T10/06-470 revision 4

Date: January 16, 2007

Subject: SAS-2: Transport layer read data flowchart

Figure 1 — Representation of transport layer (i.e., ST_TTS1 and ST_TTS3) read data operation

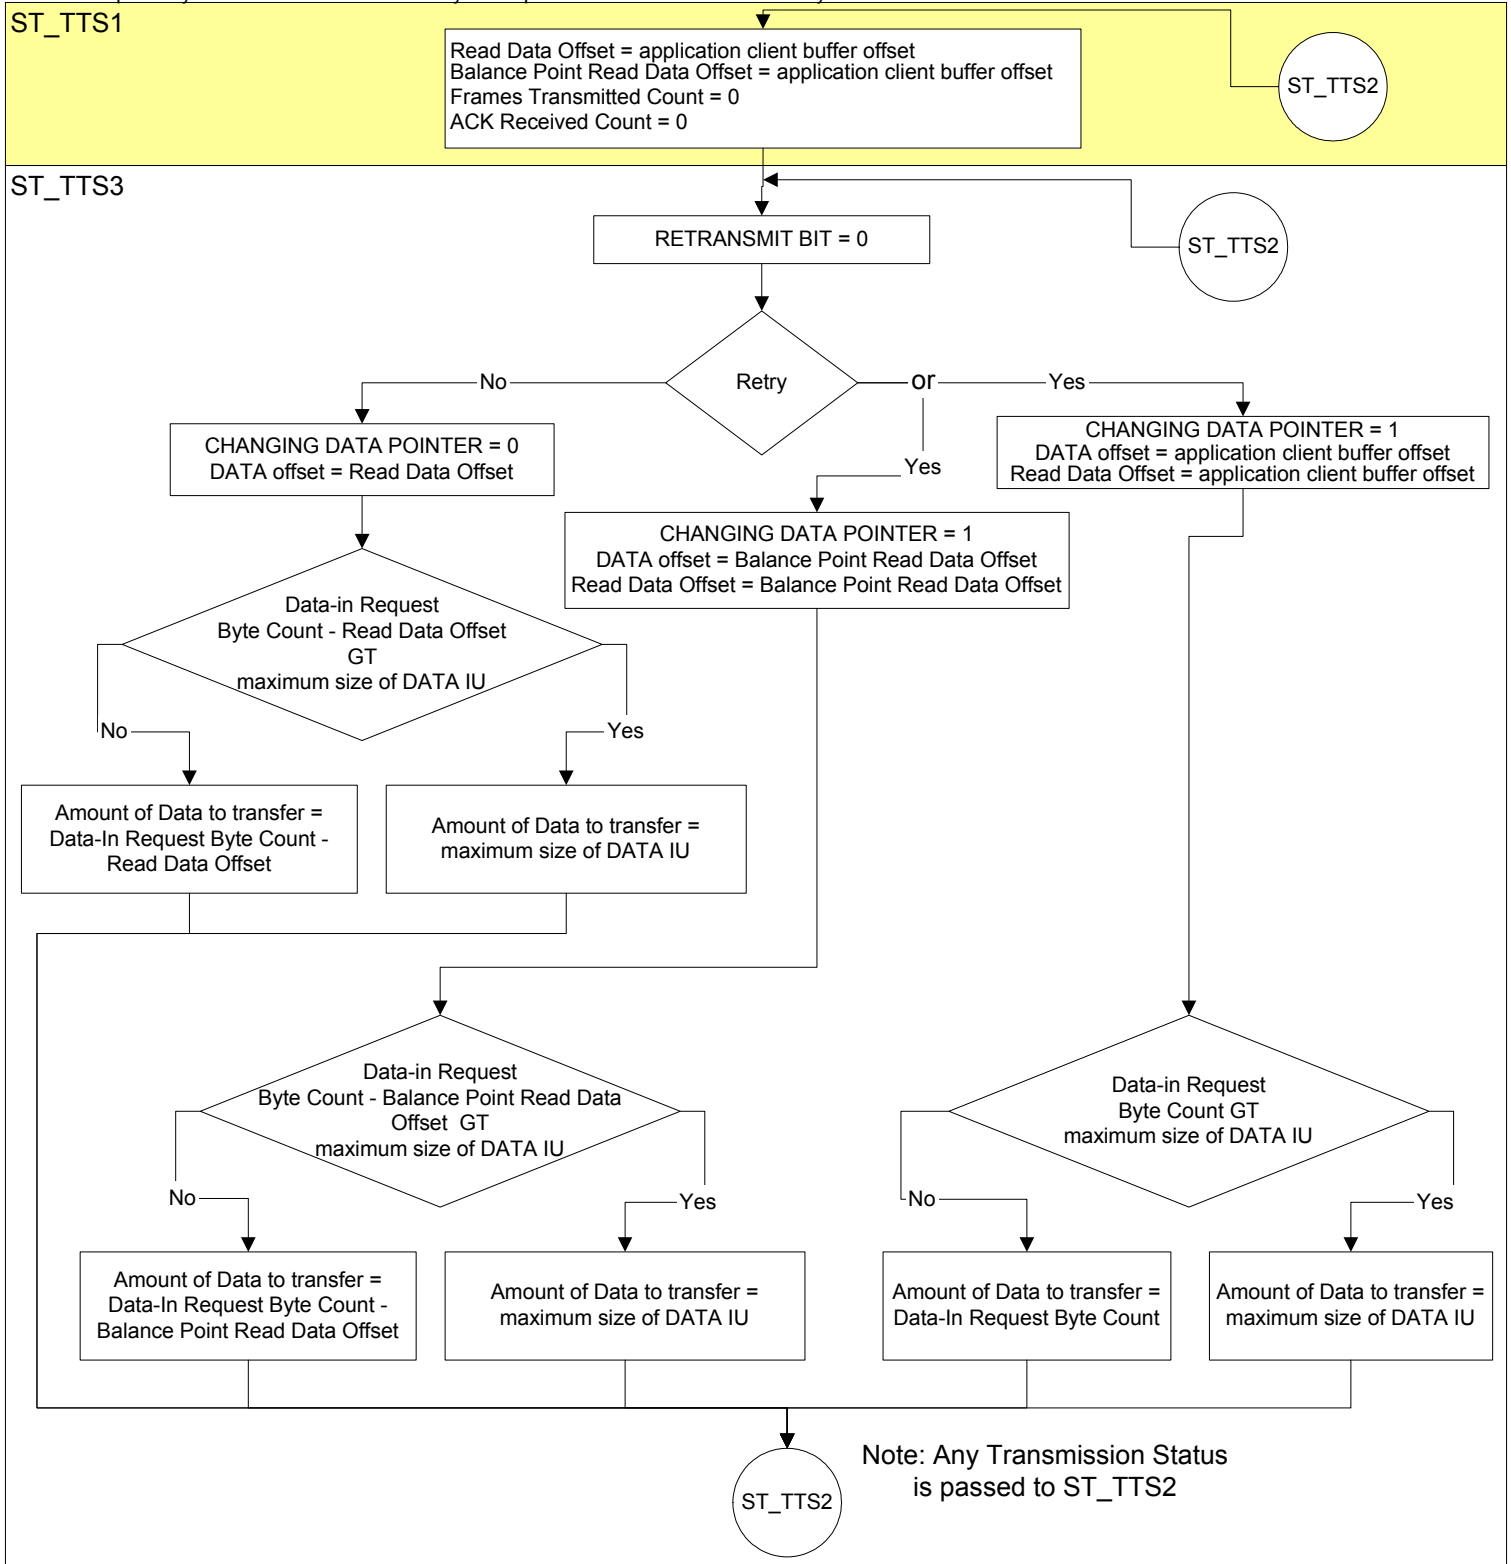
In the process of converting the words that are currently in SAS-2 there were no errors found, however, some of the wording may be somewhat unclear. Also, it was discovered that one of the conditions described in ST_TTS3 can never happen and another is already checked in ST_TTS2 so this proposal is recommending that they be deleted. See below the flowcharts for the suggested changes.

Upon entry into this state, this state shall set the Read Data Offset state machine variable to [the Data-In application client buffer offset argument](#)~~zero~~.

Upon entry into this state, this state shall set the Balance Point Read Data Offset state machine variable to [the Data-In application client buffer offset argument](#)~~zero~~.

[Upon entry into this state, this state shall set the Frames Transmitted Count state machine variable to zero.](#)

[Upon entry into this state, this state shall set the ACK Received Count state machine variable to zero.](#)

- a) set the CHANGING DATA POINTER bit in the frame to one;
- b) set the DATA OFFSET field to [the](#) Balance Point Read Data Offset state machine variable;
- c) [set the Read Data Offset state machine variable to the Balance Point Read Data Offset state machine variable](#); and
- d) in the information unit, DATA field set to the information that starts at the location in the specified device server buffer pointed to by the Balance Point Read Data Offset state machine variable and shall contain the amount of data that is the lesser of:
 - A) the Data-In Request Byte Count argument minus the Balance Point Read Data Offset state machine variable; and
 - B) the maximum size of the DATA information unit [for this Data-In request](#);

~~If a confirmation of Transmission Status (Frame Transmitted) is received, then this state shall set the Read Data Offset state machine variable to the current read data offset plus the number of read data bytes in the transmitted read DATA frame.~~

~~If a Transmission Status (ACK Received) confirmation is received, and the Transmit Frame request was for a read DATA frame, then this state shall set the Balance Point Read Data Offset state machine variable to the current balance point read data offset plus the number of read data bytes transmitted in the read DATA frame associated with Transmission Status (ACK Received) confirmation.~~
